Spokes' Response to the Draft Canterbury  
District Local Plan 2040

Published May 2024

### **CW5**

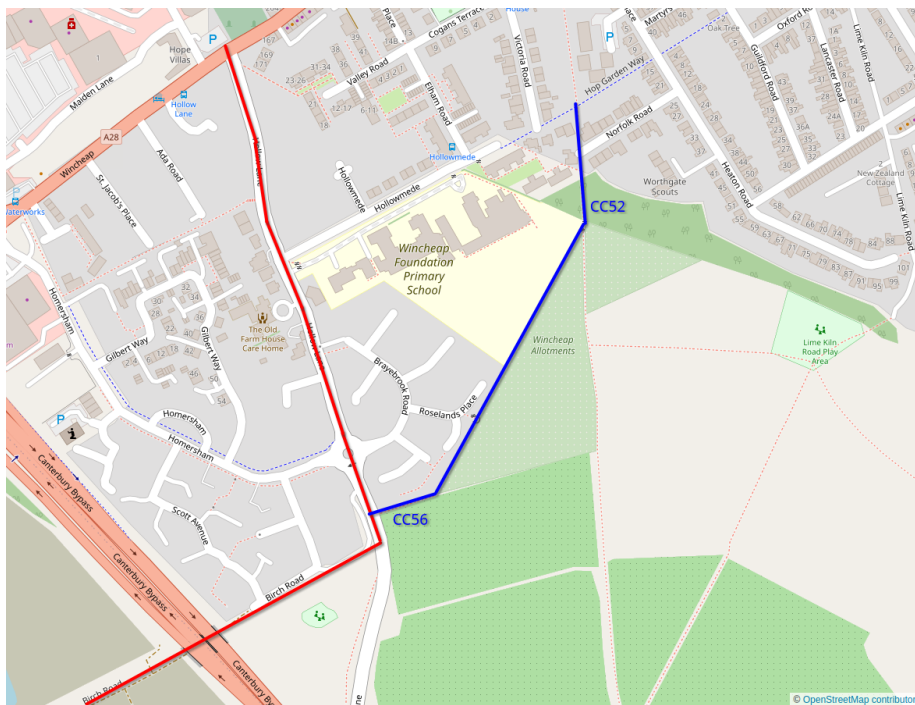
The proposal map doesn't show the new shared cycle path beside the bidirectional portion of A2 slip road and Miles Way. Not enough detail is provided. Canterbury City Council should ensure cycle paths are being built by developers to connect to a wider network and not just as a box-ticking exercise. All cycle paths should be built in line with LTN 1/20 policy<sup>1</sup>.

## CW7

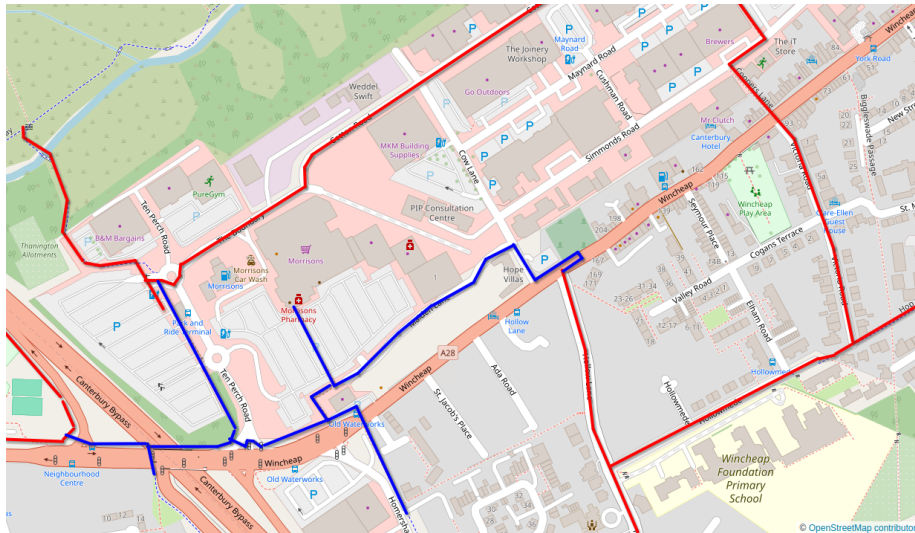
Agree - Thought must be given to the junction with Wincheap and Cow Lane. The junction is currently unfriendly to cyclists and the modal filter may be under-utilised if cyclists are intimidated by the junction further down. The pelican crossing over the A28 may be able to be converted to a toucan crossing and the path outside the cemetery widened from there to Cow Lane. Additionally,

Maiden Lane and the path at the end of it may be able to be used to offer a cycle connection into the Riverside Retail Park (Morrisons, etc.).

Additionally, we propose permitting cycling on the path beside the Wincheap Park & Ride Terminal, widening of the path beside the A28 to permit cycling, conversion of the traffic-light crossings at the following locations to permit cycling:

### **CW9**

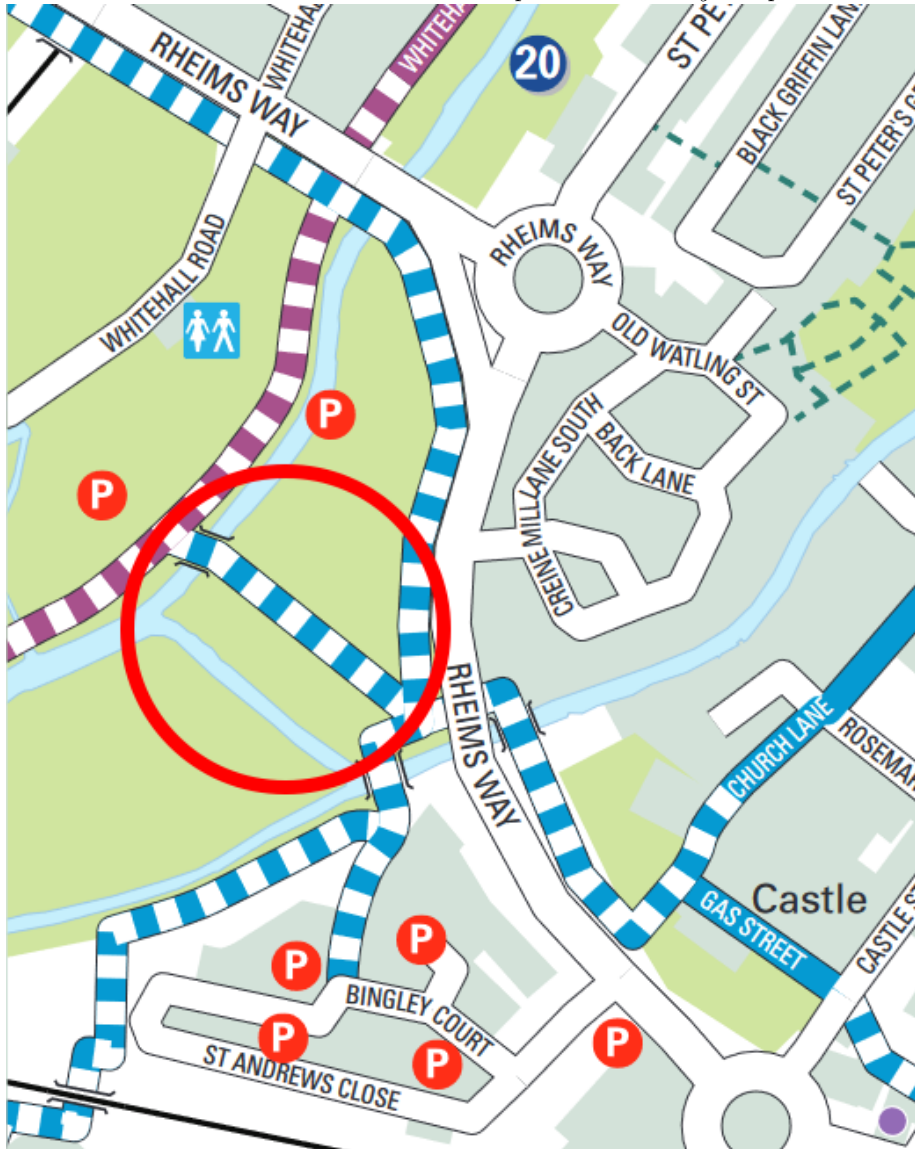
Agree - This, together with proposal CW8, will make cycling from Wincheap via the Horses & Goats Tunnel more accessible.

### **CN1**

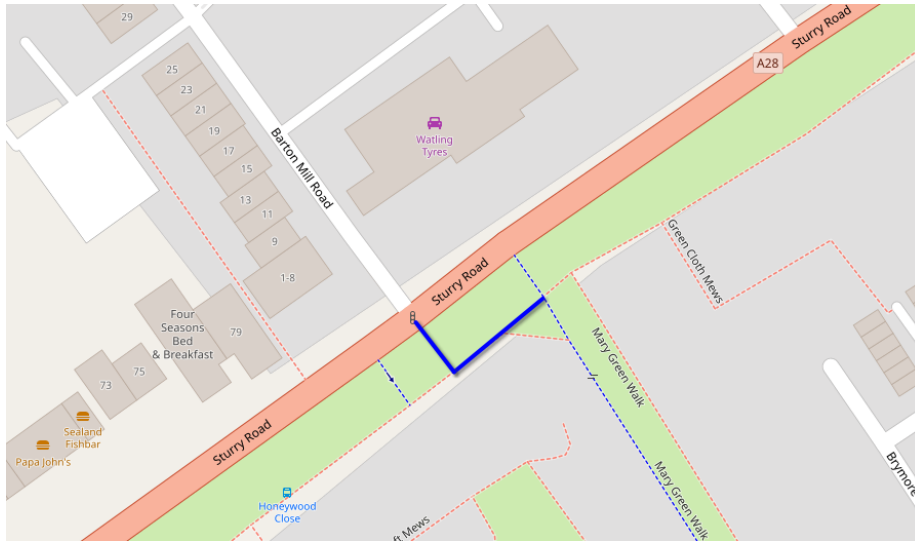
Agree - A new junction must allow for better connection with Mary Green Walk on the opposite side of the A28 road. A through crossing for cyclists would be ideal here.

As seen from the pictures there is currently no safe / legal way for cyclists to travel from Barton Mill Road on to Mary Green Walk. A safe link here could be extremely useful linking up the Local 'Along the River' Route and National Cycle Network Route One (The Fordwich Way).

approaching the lights from Mary Green Walk to be detected by induction coils. A cycle phase on the lights would then allow cyclists to head South towards the riverside path. Southbound, from Barton Mill Road to Mary Green Walk, cyclists would be able to head straight across at the lights when they change. Eastbound cyclists wishing to turn right into Mary Green Walk could either be allowed to wait to the right of the running lane, similarly to westbound traffic turning right into Barton Mill Road. Alternatively, this manoeuvre could be prohibited.

**CN11**

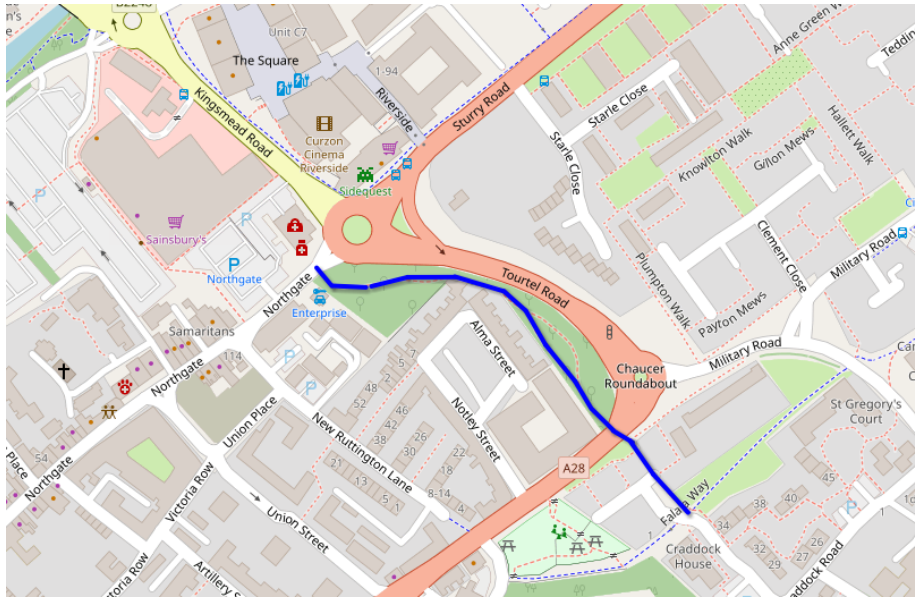
Strongly Agree - Cycle lanes must be segregated. The reduction in motor vehicle capacity will also help to achieve a modal shift towards more sustainable modes. A shared cycle path away from the road may also be able to be delivered between Falala Way and Northgate as indicated below, if sufficient space behind the Alma Street houses can be achieved:

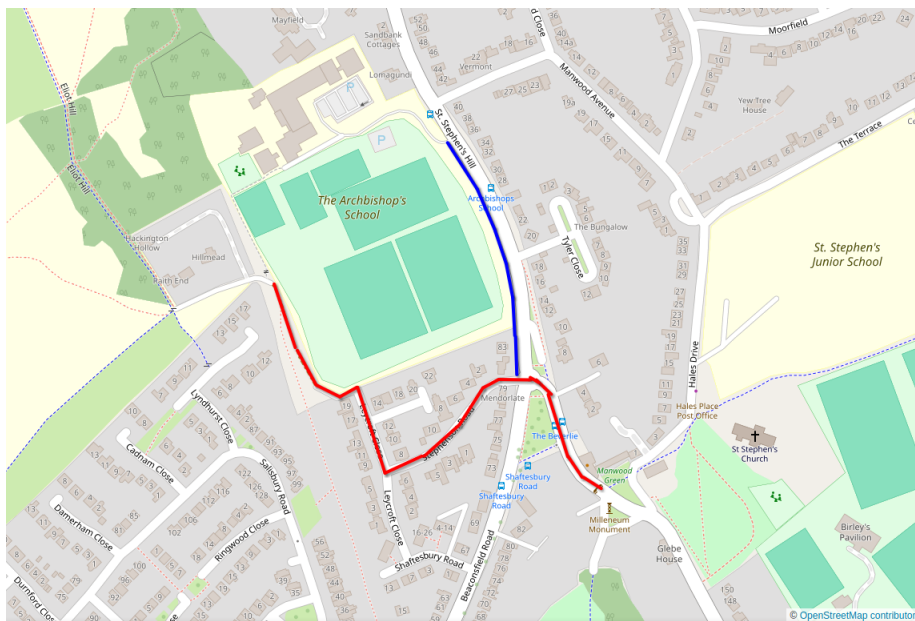
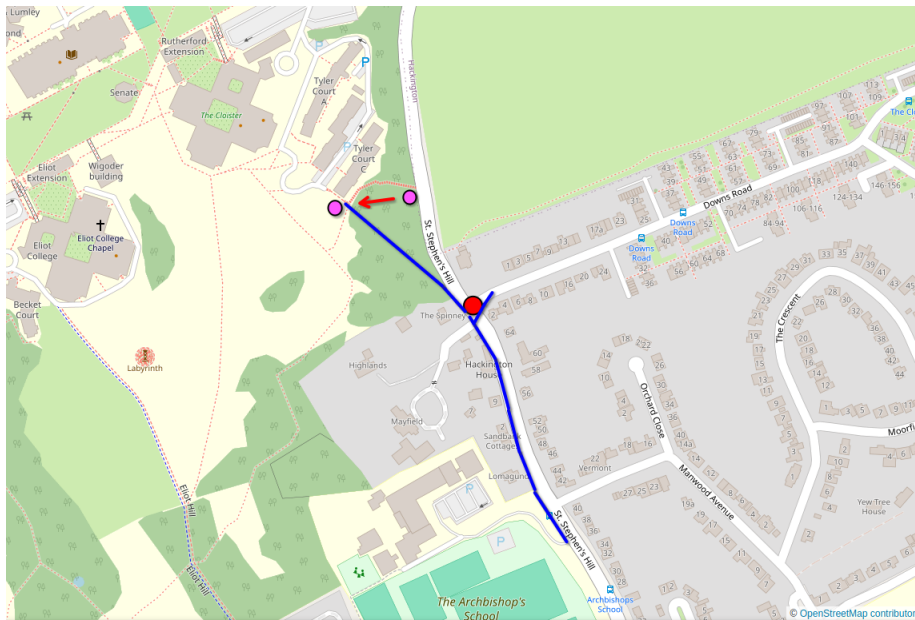
The proposed shared path beside Farleigh Road should be engineered to ensure that it is possible to cycle from there onto Bird Cage Walk. Additionally, ensuring that the Farleigh Road shared path reaches as far as Hever Place will ensure that the residents in Hever Place and Wichling Close can easily make use of this proposed route to reach the riverside path. Finally, removal of the barrier onto Bird Cage Walk from Hever Place, and permitting cycling on this short section of path, would facilitate the same residents wishing to head West along Bird Cage Walk towards Hales Drive, since this would be a more logical route.

Proposal CS1 is shown in red, and our proposals are shown in blue. Further, we observe that it would be beneficial if the shared cycle path from Walden Court could be integrated into the scheme, since that would enable the residents of Market Way and its adjoining roads to easily reach this facility and, from there, the wider cycle network.

### CS11

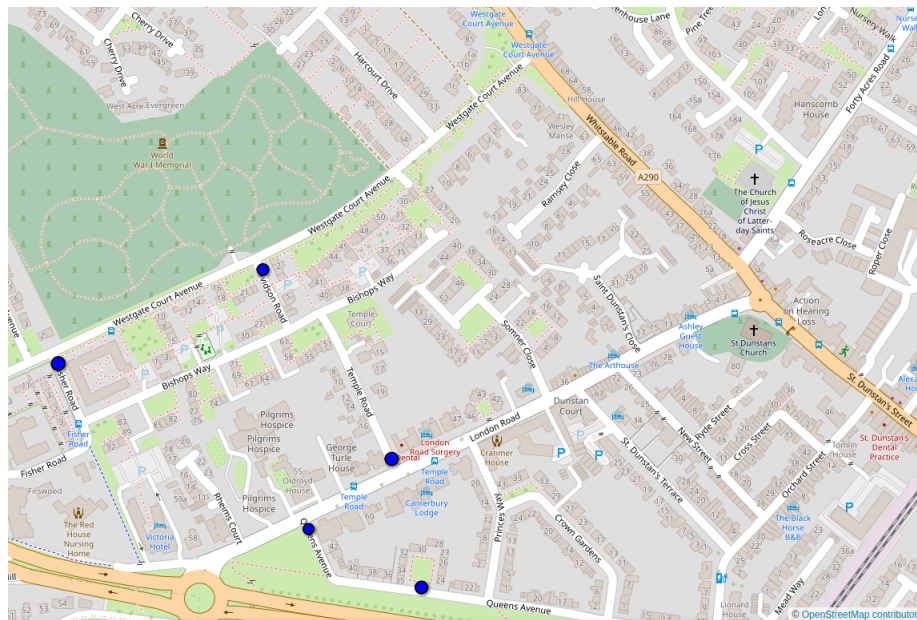
Agree - Highlighting of route is good, modal filter on Queen's Avenue should be viewed as a low priority project. Traffic volume is already extremely low.

The text and map don't agree here. The text makes reference to an existing route, but the lines on the map follow the length of London Road to the

### **H5**

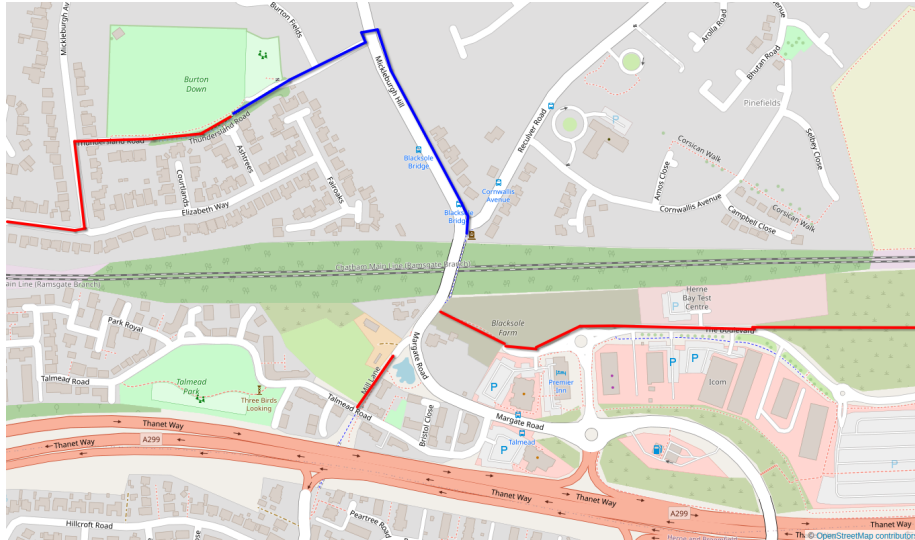
Agree - This will allow Herne to be more easily reached from north of the railway line. In conjunction with H6 it'll also link the substantial new development surrounding Bogshole Lane and May Street to be connected with Herne.

## H13

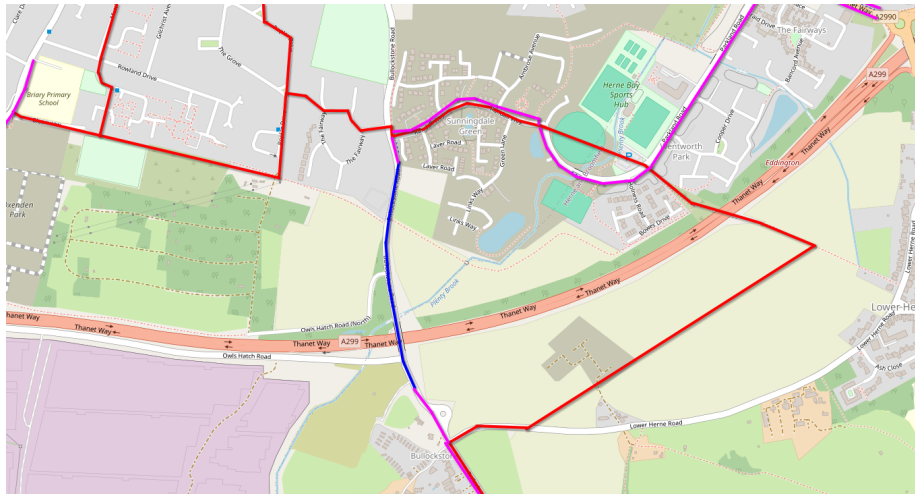
Agree - This is mislabelled as H12 on the proposal plan. This route will provide a traffic-free cycle route to reach the proposed new school at Chestfield and employment sites in Whitstable.

### **H19**

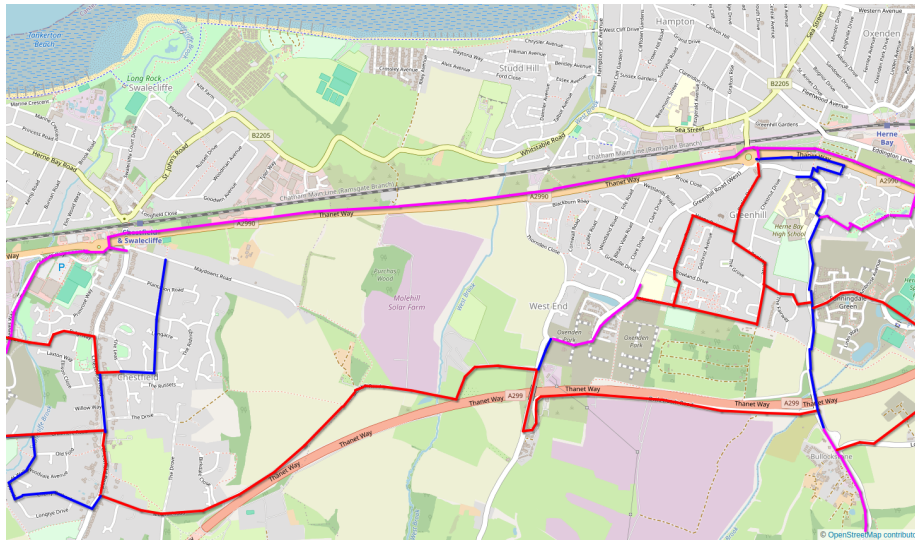
This proposal isn't indicated on the map. It appears to overlap with our proposals on H18. However, rather than using on-road traffic calming, we believe that developing a traffic-free shared cycle path will achieve a greater level of uptake, especially amongst school children, where it allows a greater level of social interaction than an on-road alignment.

## H21

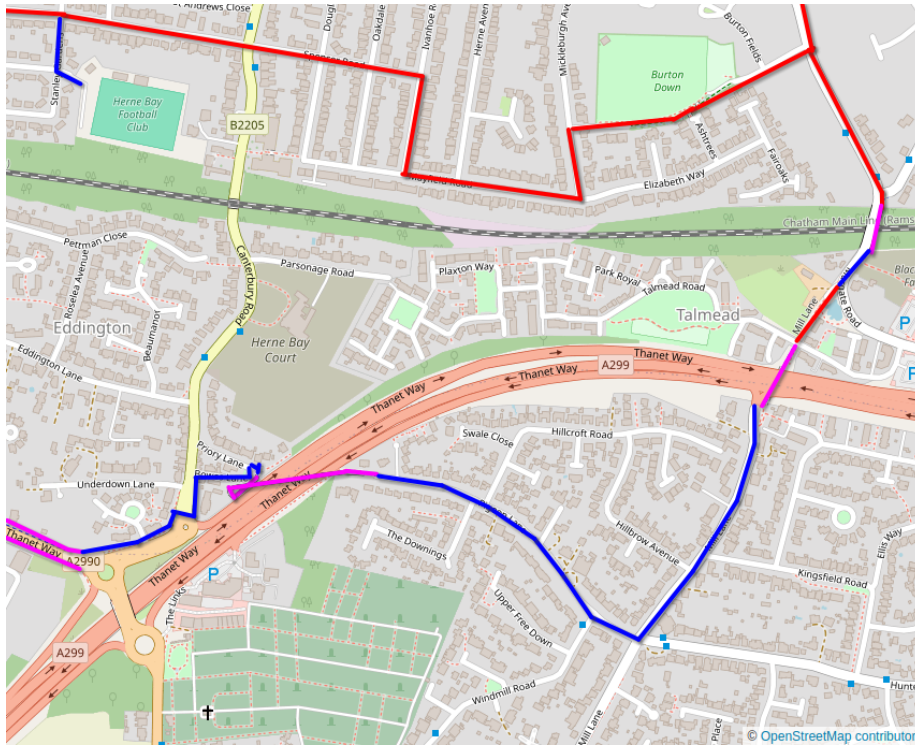
Agreed - This isn't indicated on the proposal map, thus we cannot determine whether the alignment being proposed matches exactly with our comments made on H7. In addition to this we would sign a connection using Mill Lane and Pigeon Lane to reach the cycle bridge over the A299 Thanet Way to Priory Lane and Bowes Lane. From Bowes Lane the path on the east side of Canterbury Road can have cycling permitted and a crossing made over to the path on the west side, by adjusting the island nearer to the roundabout. The path here can then be widened, crossing the entrance to St. Augustine's Court, to meet the existing shared use cycle path on the north side of the A2990 Thanet Way. This would then provide two alternate cycle routes connecting Herne with Herne Bay.

## W14

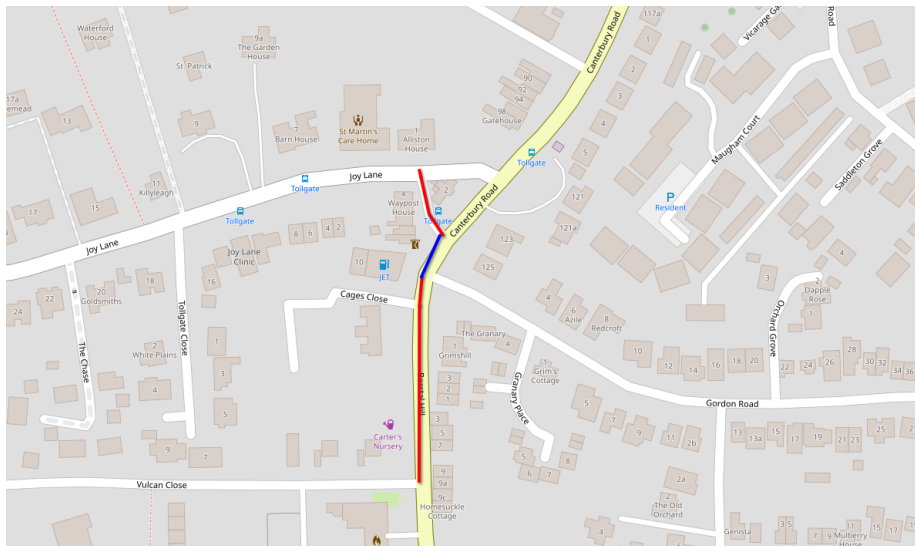
Agree - Particularly welcome if cyclists can gain access to school without having to cycle along Joy Lane (heavy traffic) however this is not entirely clear.

A widened footway would be preferred to cycle lanes, since this affords cyclists greater protection and cyclists can feel hassled by drivers when unable to climb hills quickly. Primary schoolchildren are unlikely to cycle on Borstal Hill in cycle lanes due to safety fears, but widening the footway to permit cycling there is more likely to encourage them to cycle.

## W16

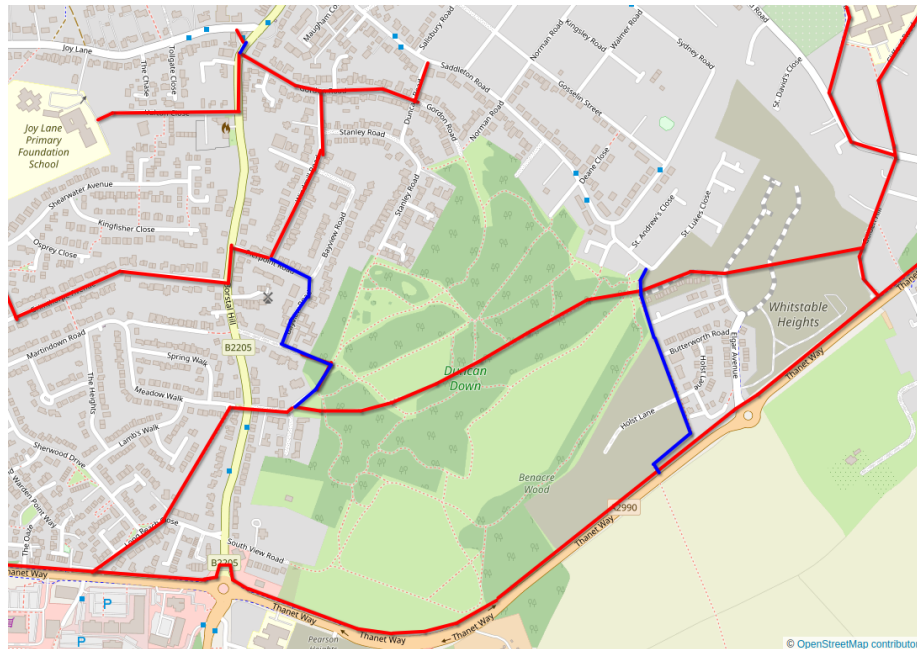
Agree - The Zebra crossing on Borstal Hill should be adapted to allow cyclists to cross. Within Duncan Down another connection should also be formed to Clovelly Road, thereby allowing a connection via Bayview Road to proposals W13 and W14. Additionally, connections to St. Andrew's Close / St. Luke's Close should be formed, providing cycle permeability to the housing here, too. This proposal will serve the new housing at Whitstable Heights well.

In forming the connection to St. Andrew's Close / St. Luke's Close we believe that using the CW20 alignment would work well. This can also be upgraded to permit cycling up to the NCR1 path on the north side of the A2990 Thanet Way (proposal W8).

## W19

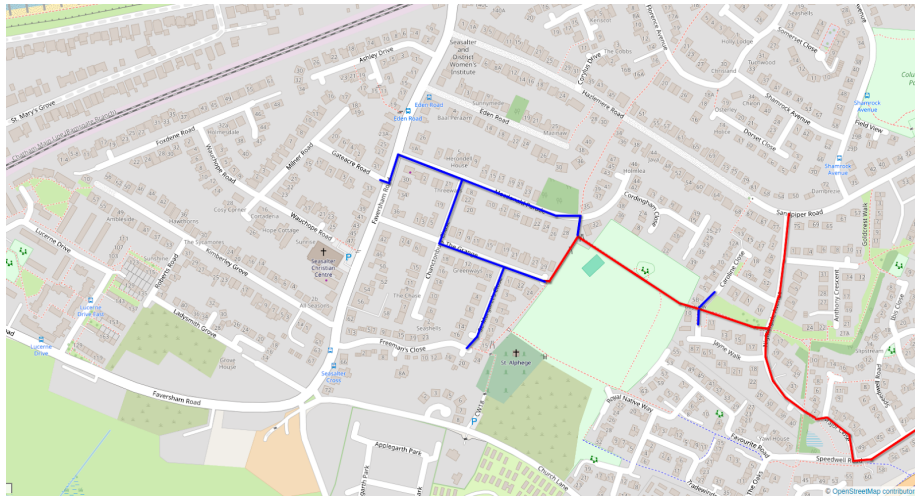
Agree - We would also support permitting cycling on the existing path between Caroline Close and Jayne Walk, which straddles this proposed route, such that the natural route is permeable for cyclists.

We note that an alternative shorter connection at the western end of this proposal could be formed via CW18 to Macdonald Parade. This would better suit a potential crossing over Faversham Road between Macdonald Parade and Gateacre Road, since the visibility is better here than at the junction between The Grange and Faversham Road.

**R8**

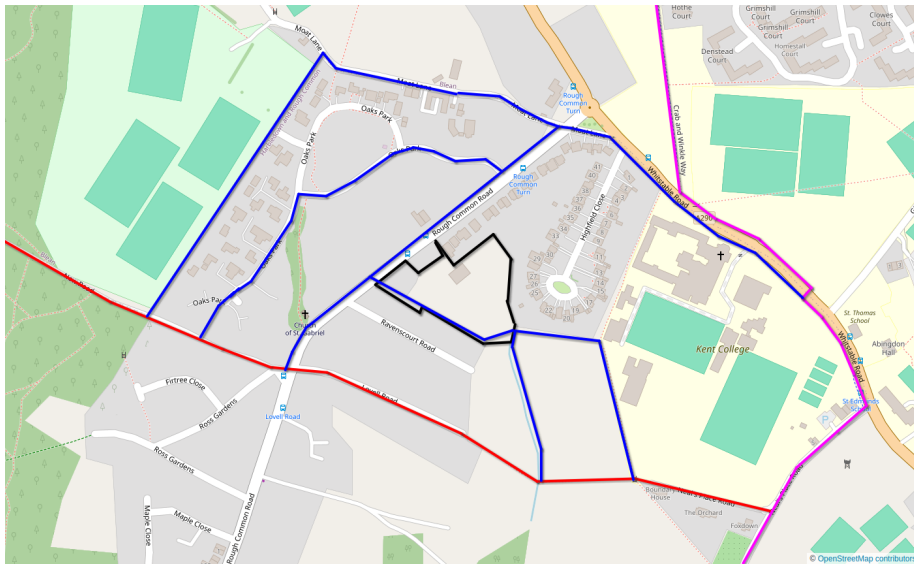
Agree - This will offer a quieter route between Canterbury and Faversham than the current narrow path beside the very busy A2 dual carriageway. The portion between Neal's Place Road and Lovell Road is narrow and steep in parts, and would require a small bridge to be replaced. Also, the junction between Lovell Road and Rough Common Road has reduced visibility. So consideration of an alternative traffic-free alignment along the Whitstable Road, Rough Common Road corridors and the surrounding roads may overcome this. We show some potential other options in the map below.
